## MAIN HOUSE - FIRST FLOOR

### First Floor Proposed changes:

Proposed Change FF1 to Stair and Master bathroom

**Proposed new layout to breakfast room and family room  
(in blue revised elements, in dotted previously consented)**

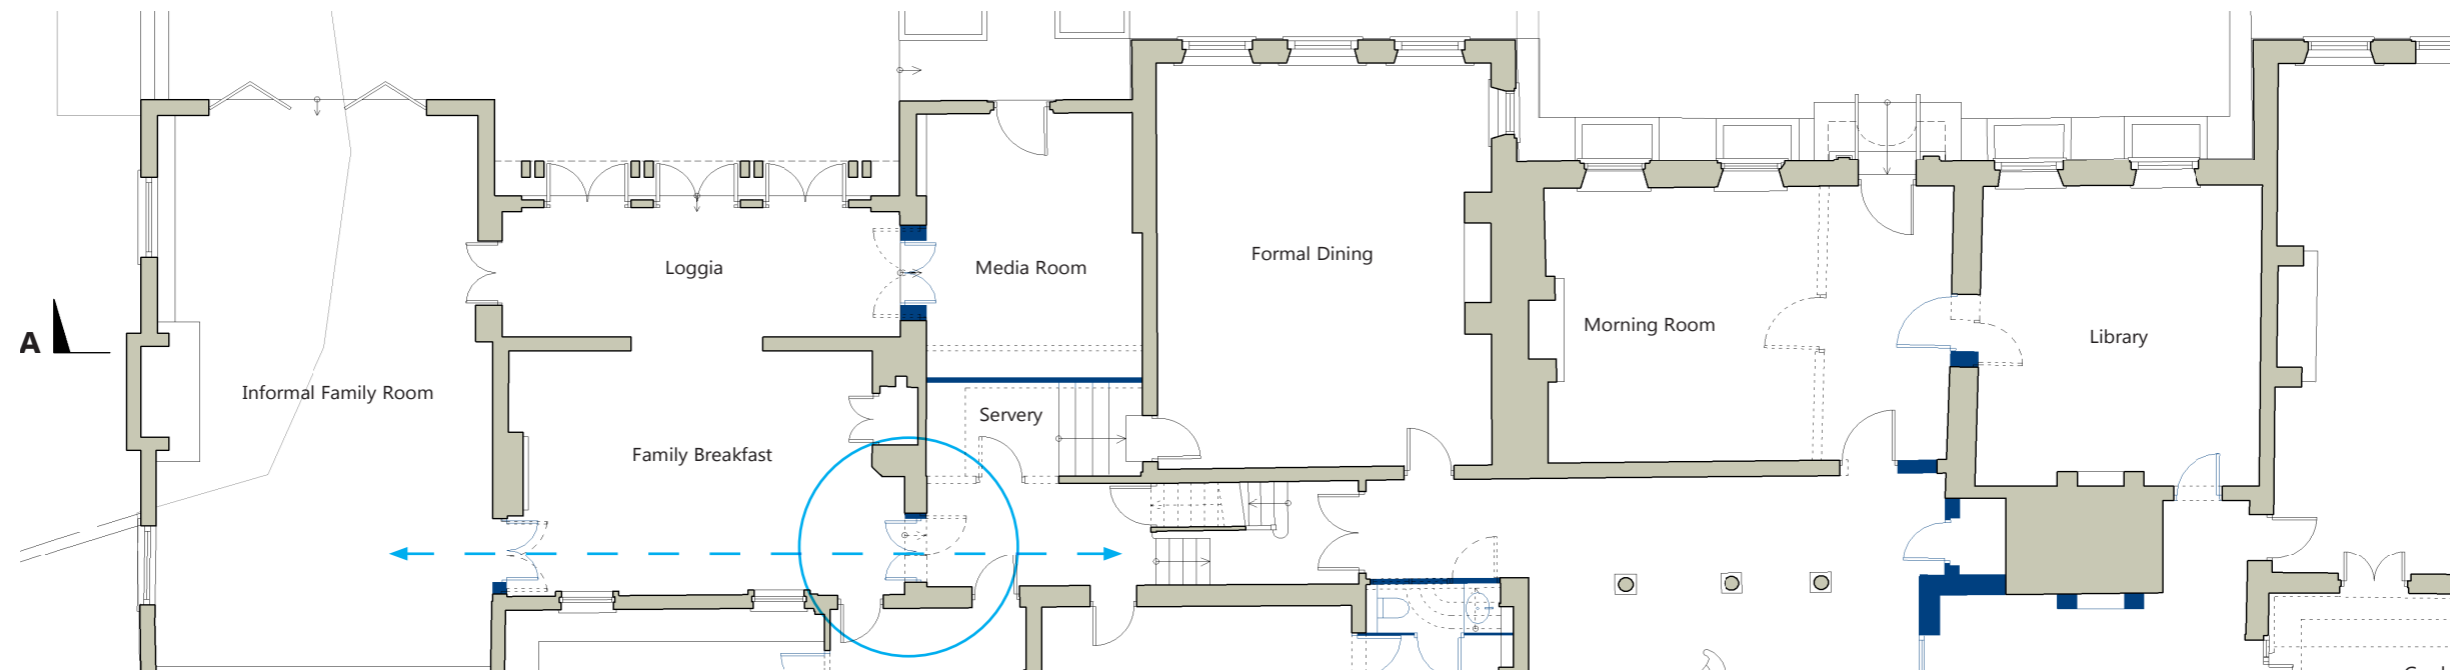
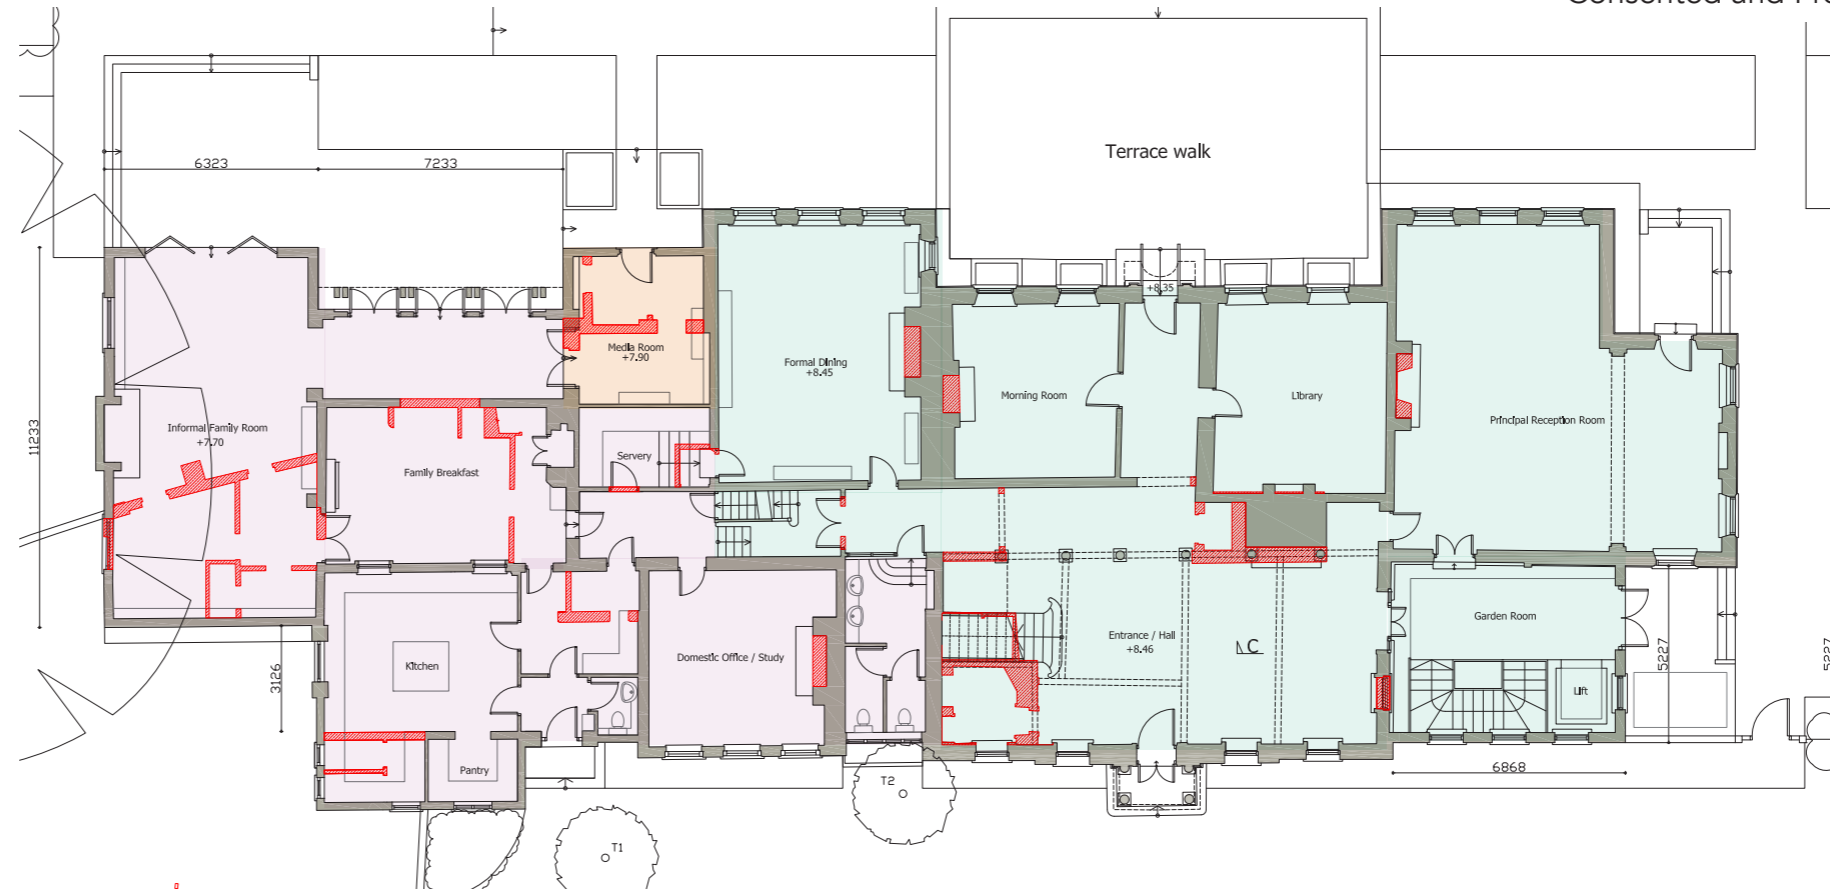
A new double door is proposed to enhance circulation and access from the main hallway all the way to the new informal family room. This further establishes a visual connection, with minimal impact on the building fabric.

# MAIN HOUSE FIRST FLOOR

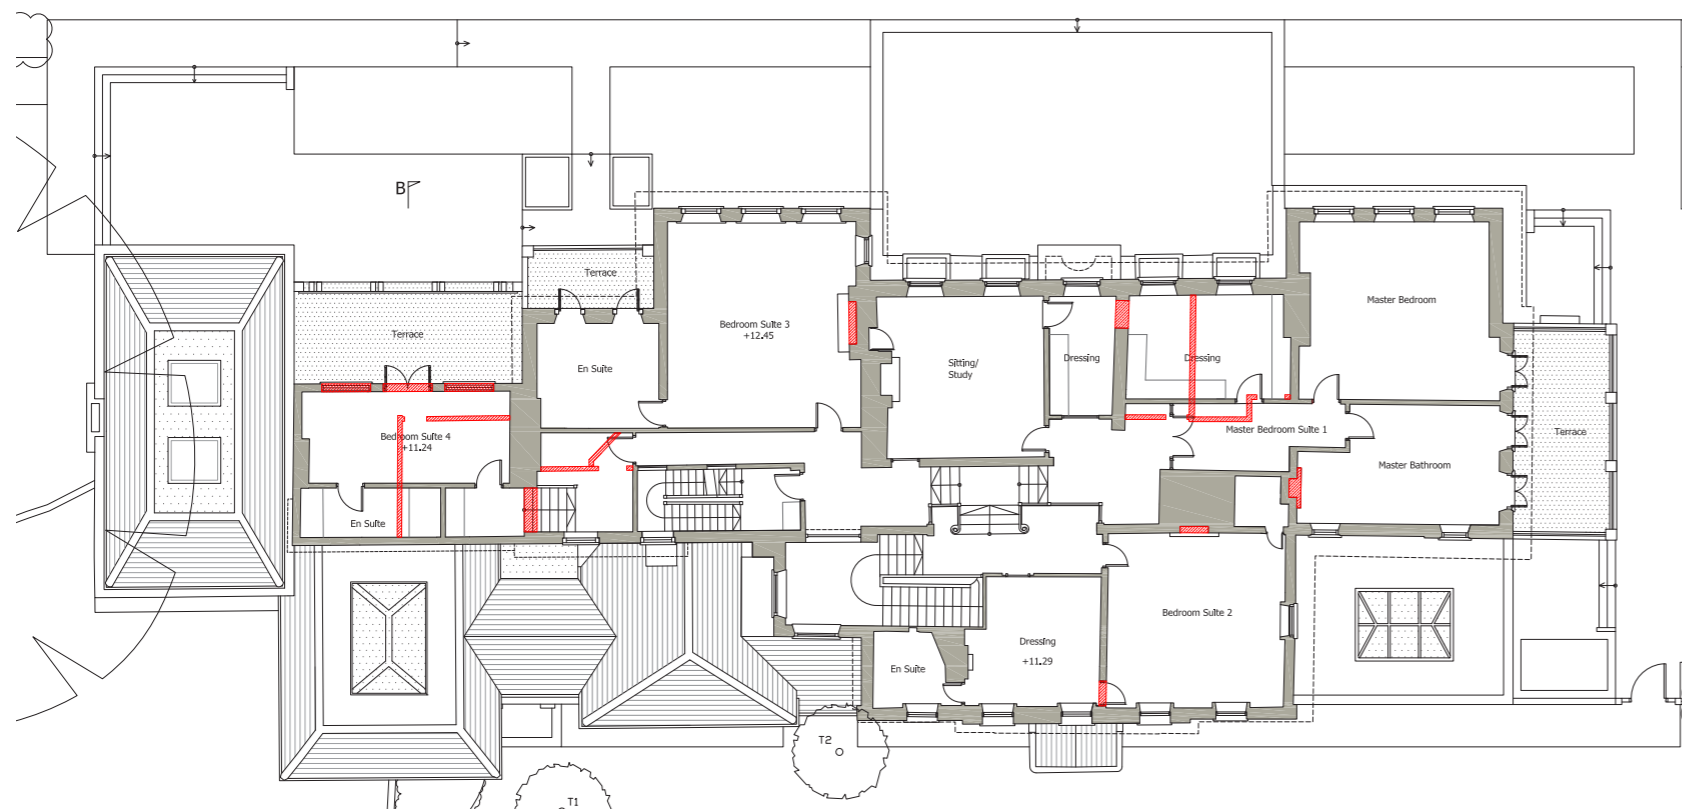
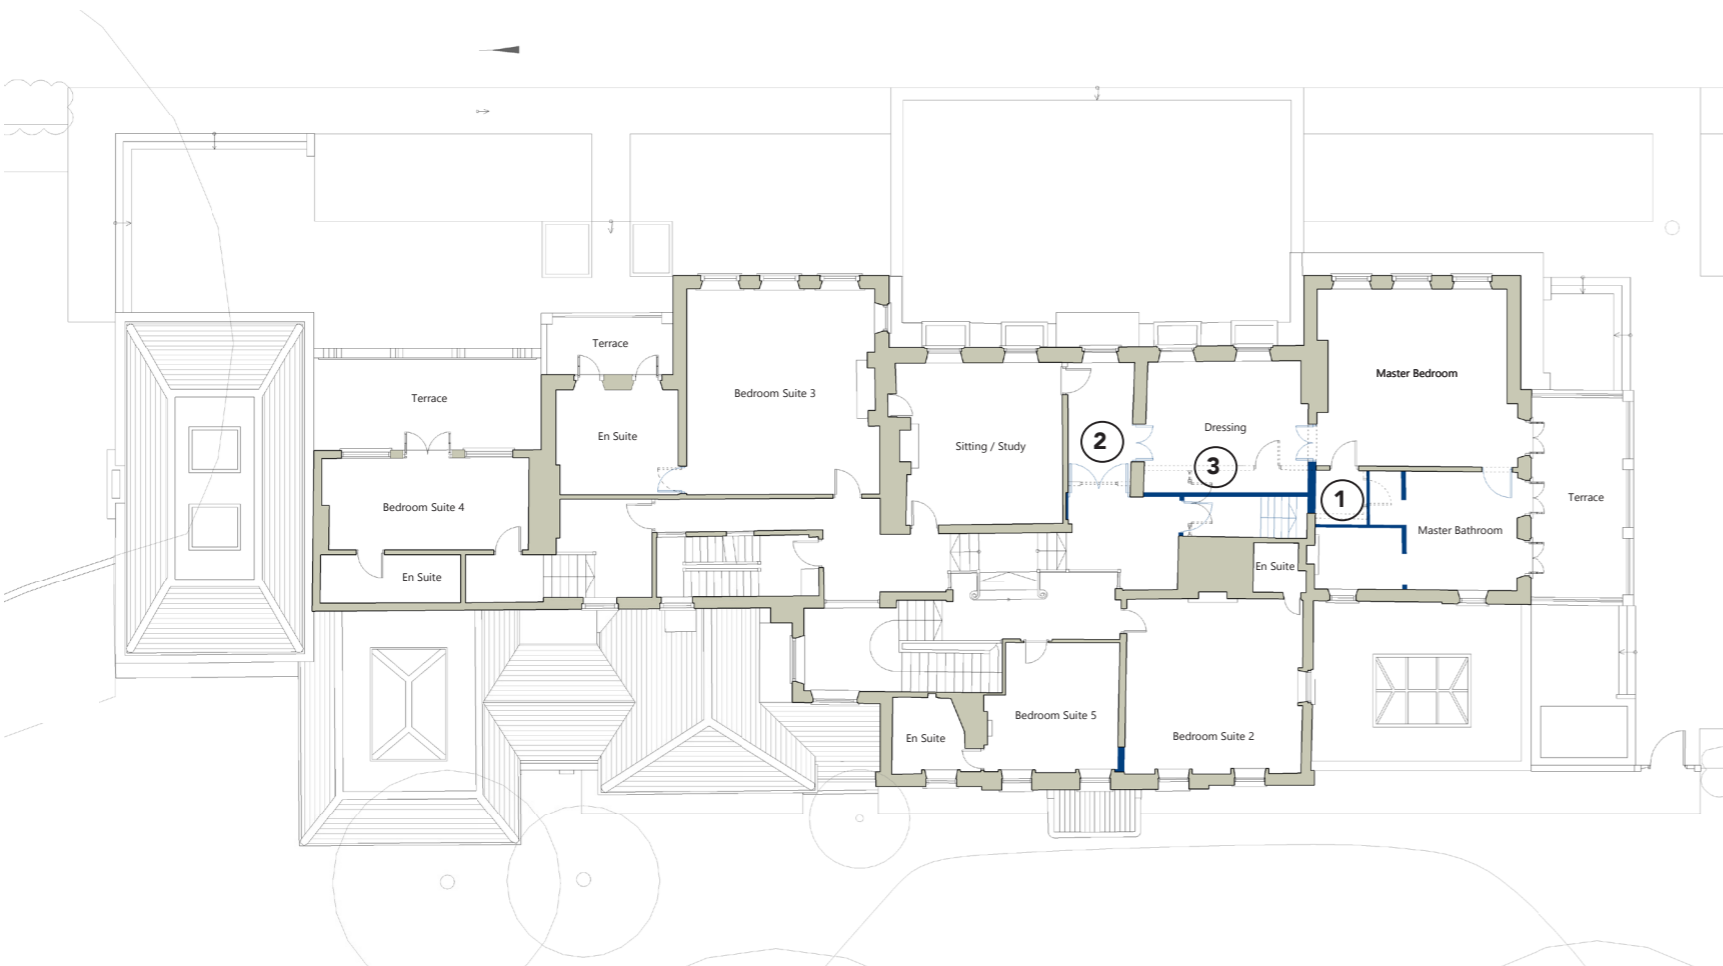
The levels are rationalised to improve access across the building.

The level of the Media room is brought to +7.70 removing steps introduced in the consented scheme.

The space dedicated to the media room has also been increased by reducing the width of the Servery.

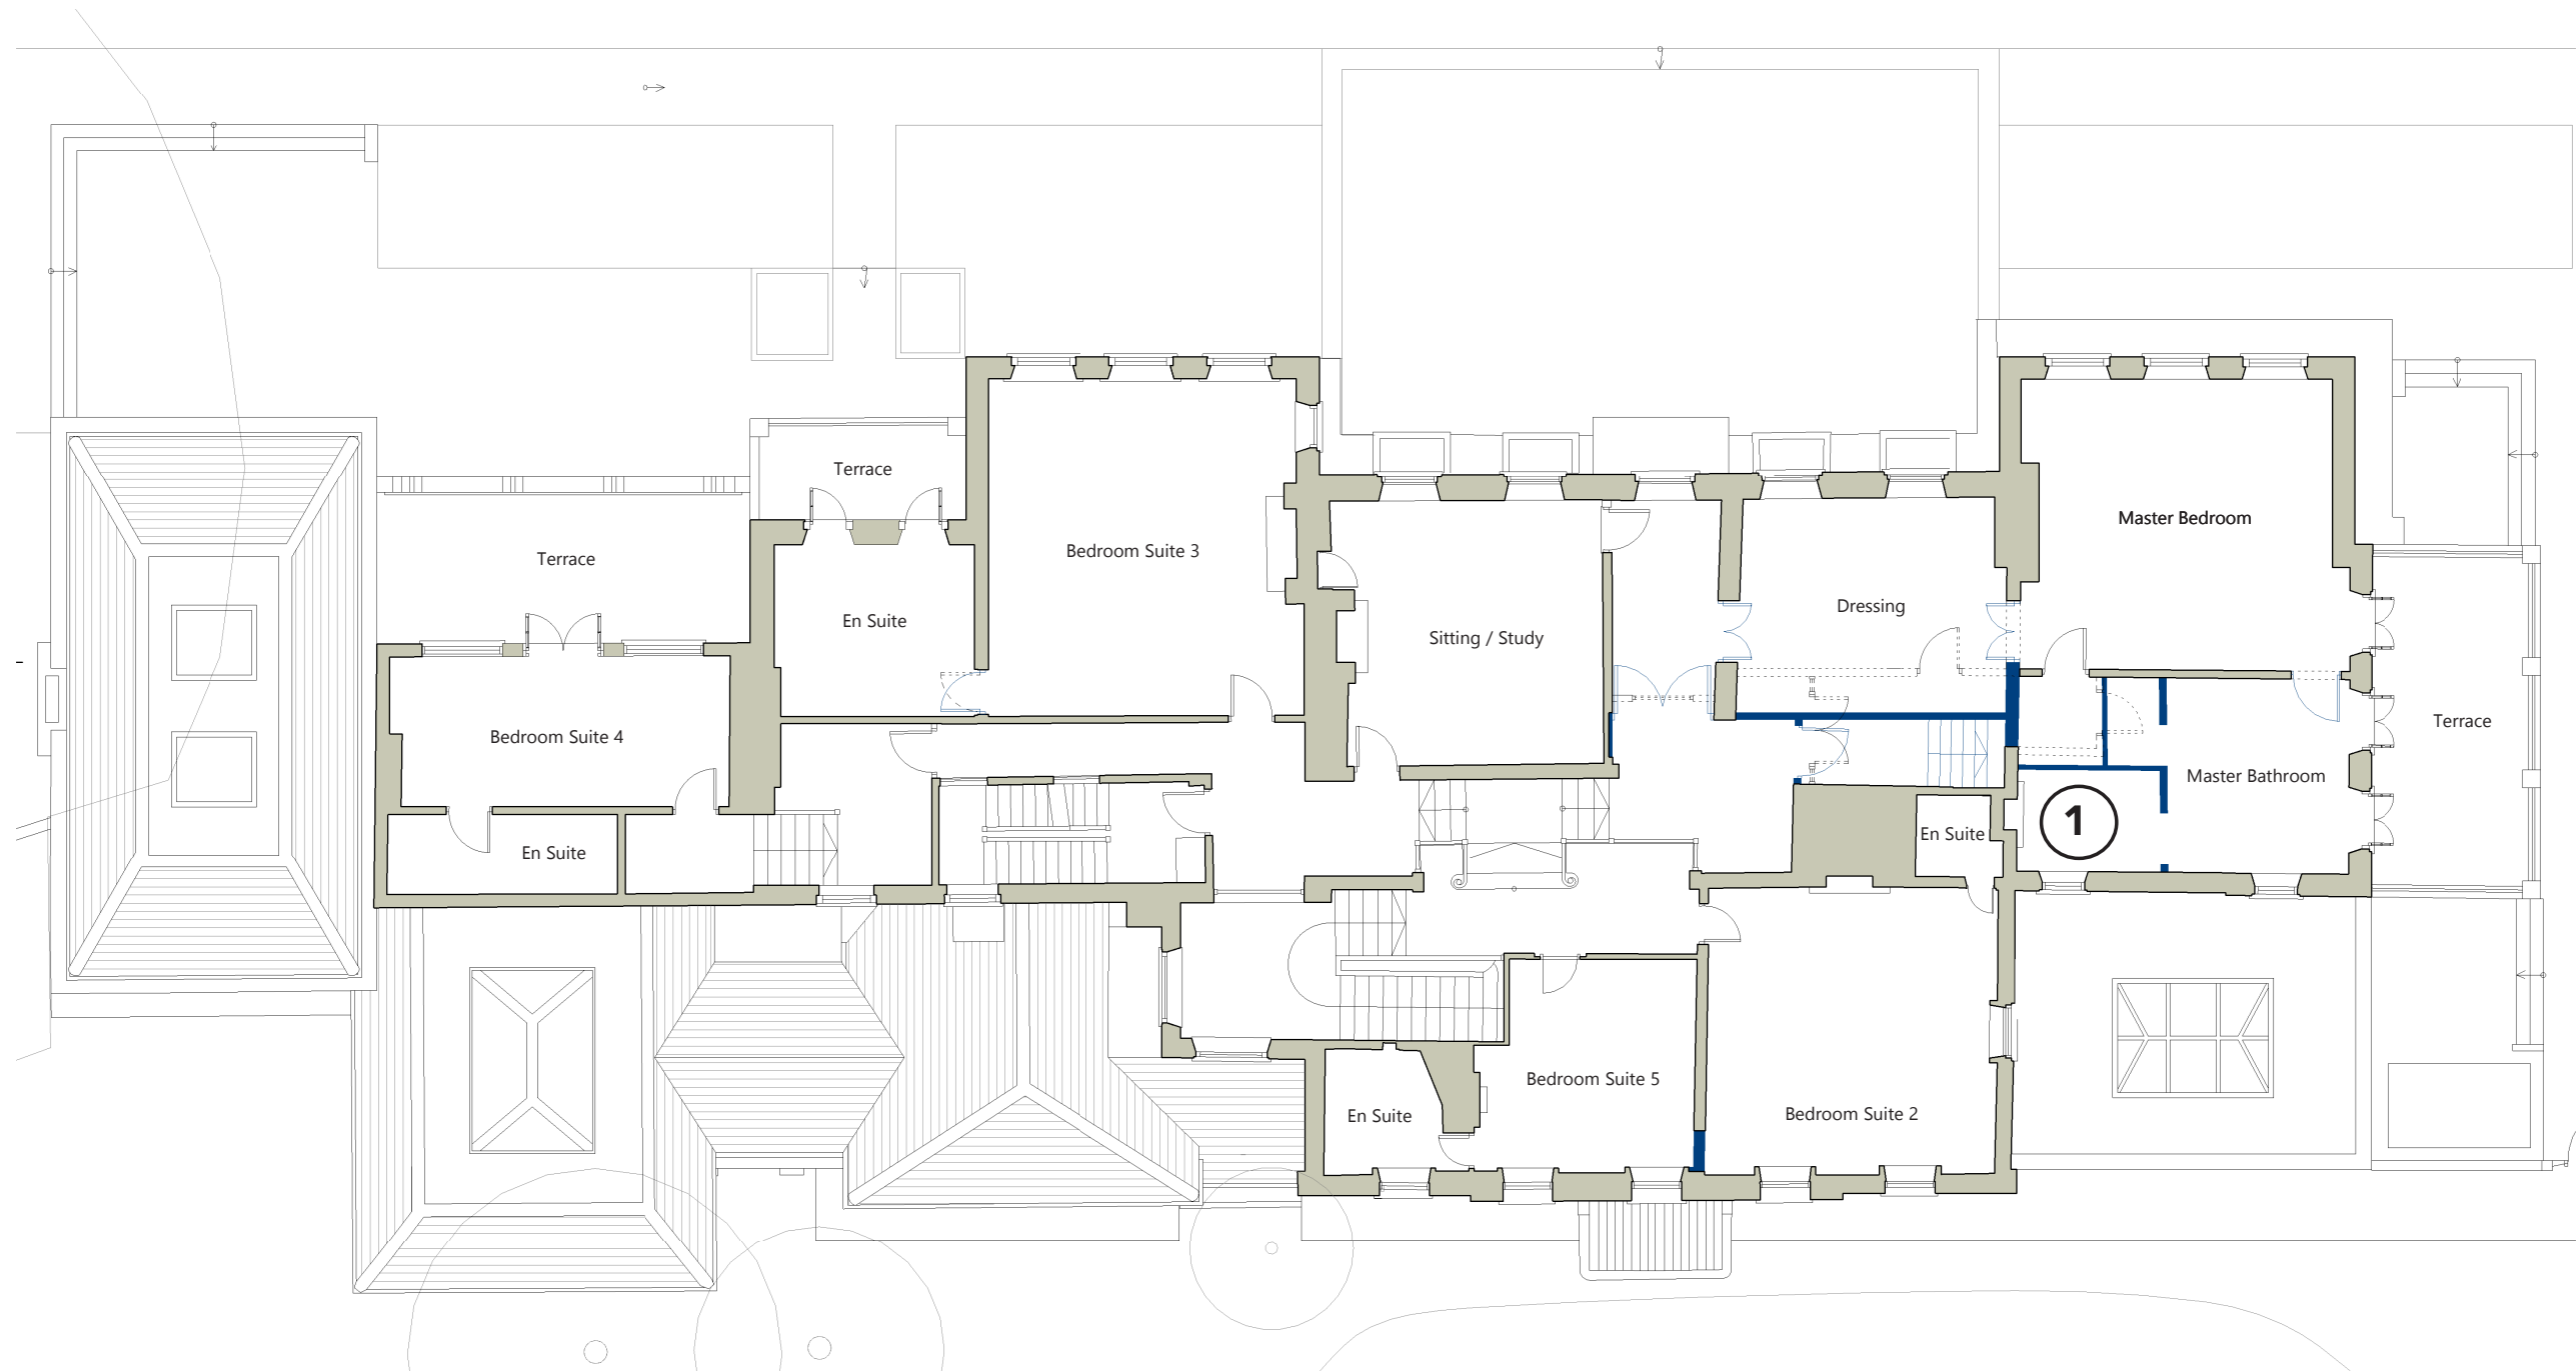
- FF1. New stair to access consented attic bedroom. Previous access was not achievable without alteration to the roof profile
- FF2. Relocated door to master suite entrance to avoid weakening junction with external wall
- FF3. Approved new partition moved west to closer reflect original room proportion

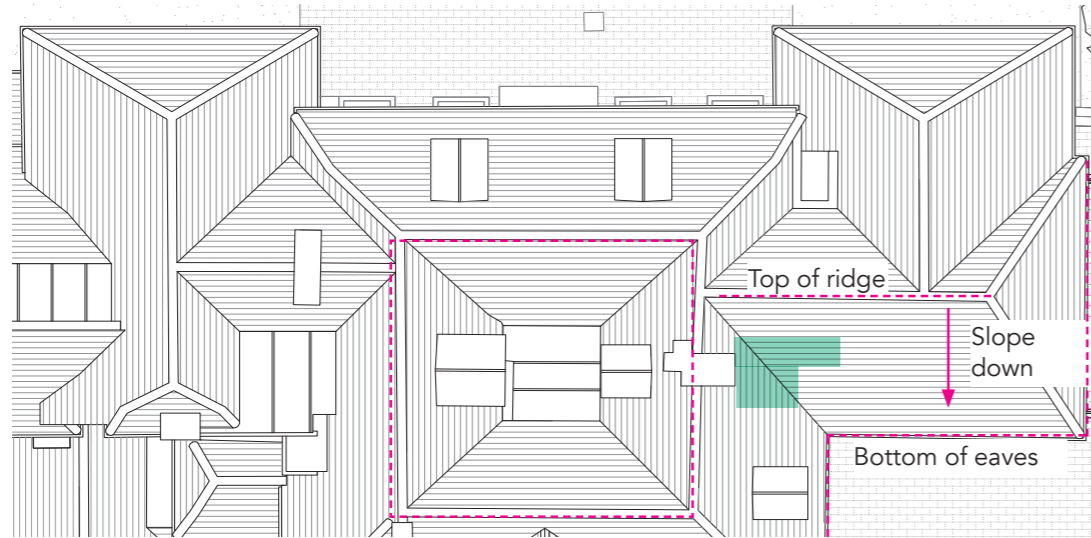
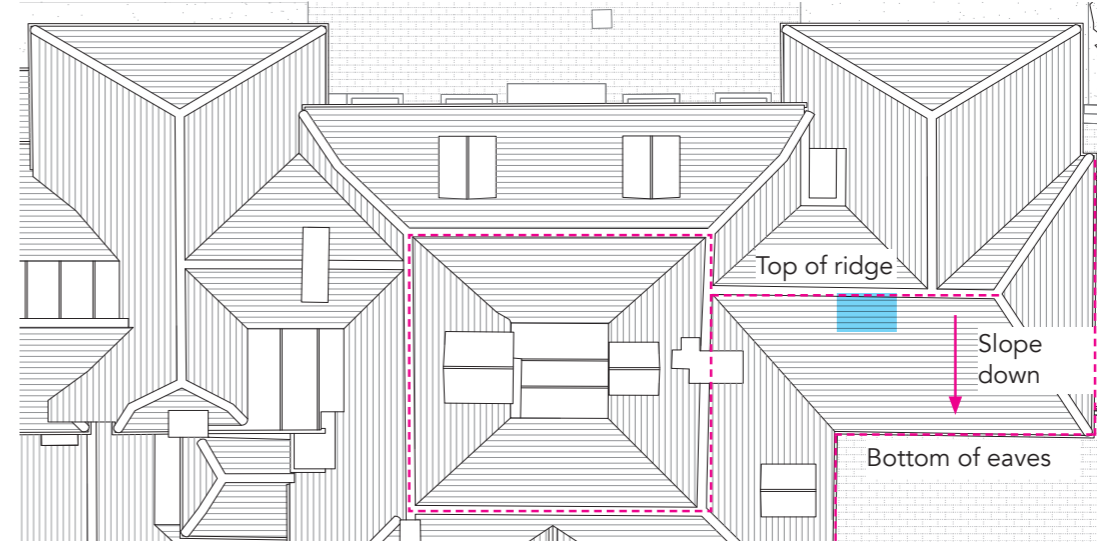
Position of the consented stair in relation to the roof's ridge

Position of the proposed stair in relation to the roof's ridge

Introducing the stair at this location would result in too little headroom internally and would ultimately require change to the roof profile.

Shifting the stair case towards the centre of the ridge, resolves the head height without any alteration to the existing roof profile as all the works can be internal. In addition, the circulation is improved with all the main bedrooms accessible from the main staircase.
